Groundwater Transfer Review Summary Form

Transfer/PA # T- 14415

Ground Water Review Form:

Application: T-14415

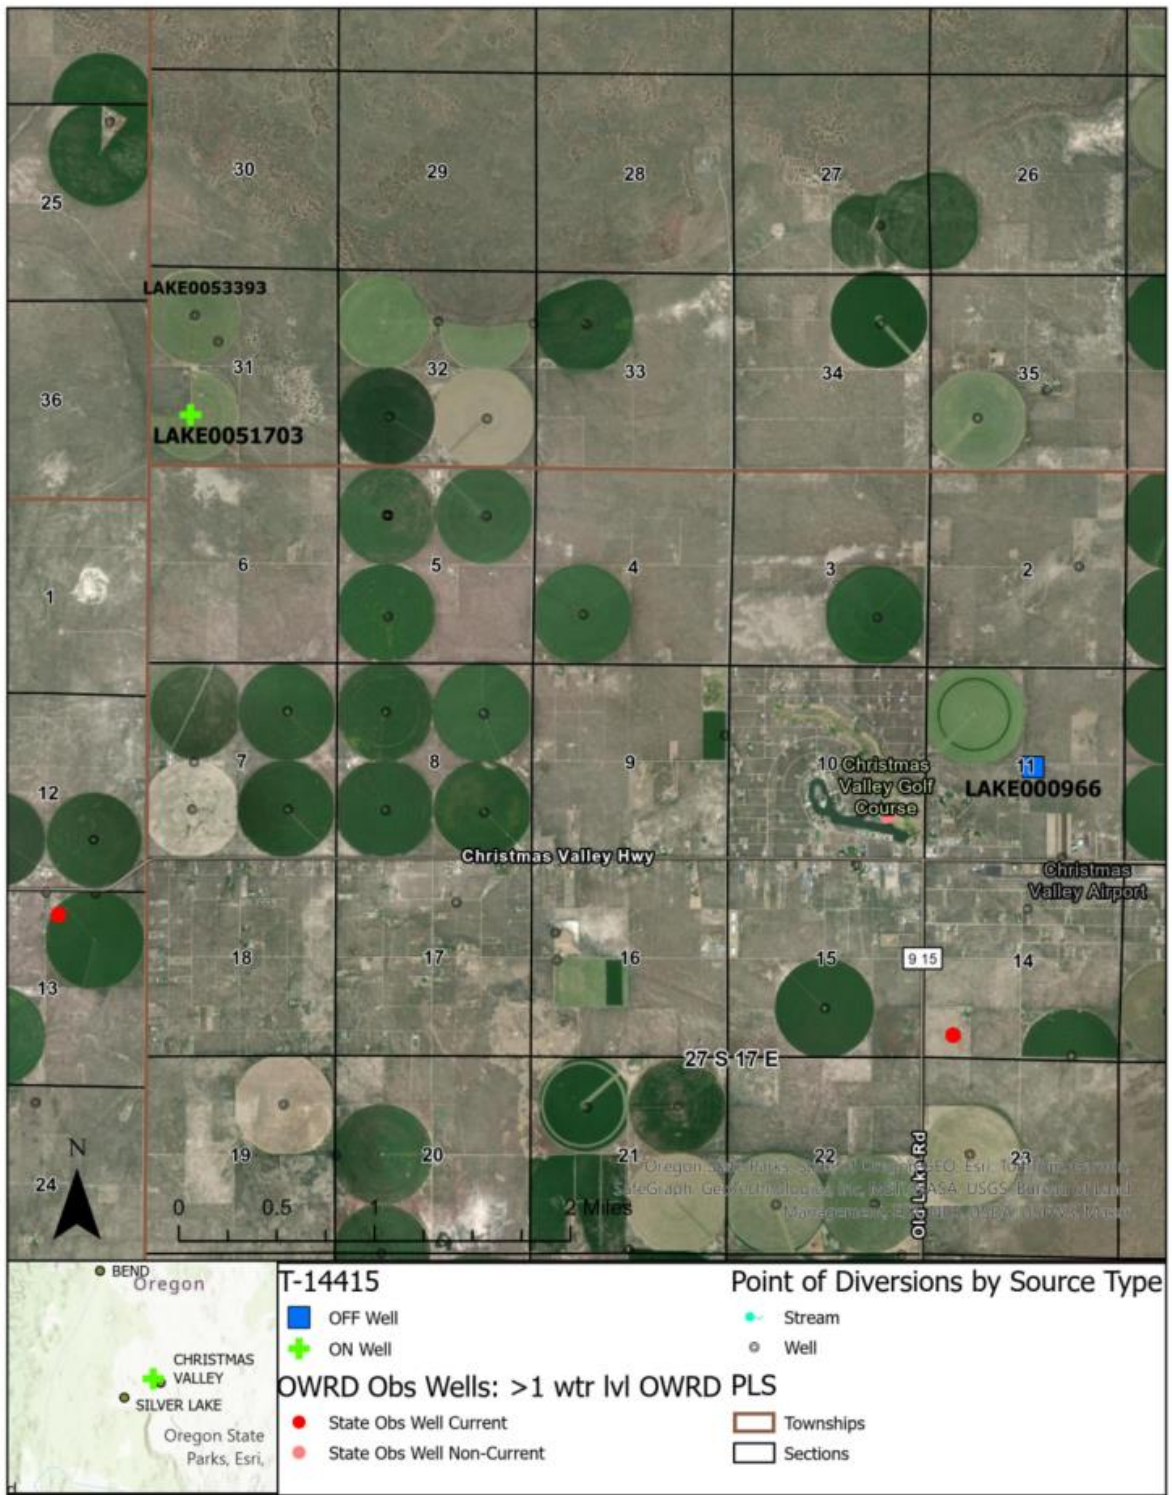
5. a) Will this proposed change, at its maximum allowed rate of use, likely result in an increase in interference with **another surface water source**?
 Yes No Comments: The proposed POA LAKE 51703 is closer to both Paulina Marsh and Silver Lake than the authorized POA 966. The reduced intervening distance between the proposed POA and the above listed surface water sources would likely result in an increase in interference with those surface water sources.

Provide context for minimal/significant impact: Proposed POA LAKE 51703 is located 12.5 miles from Paulina Marsh and 12 miles from Silver lake. While this is a reduction of distance when compared to authorized POA Lake 966 (16 miles and 13.5 miles respectively), any increase in interference is expected to minimal at those distances.
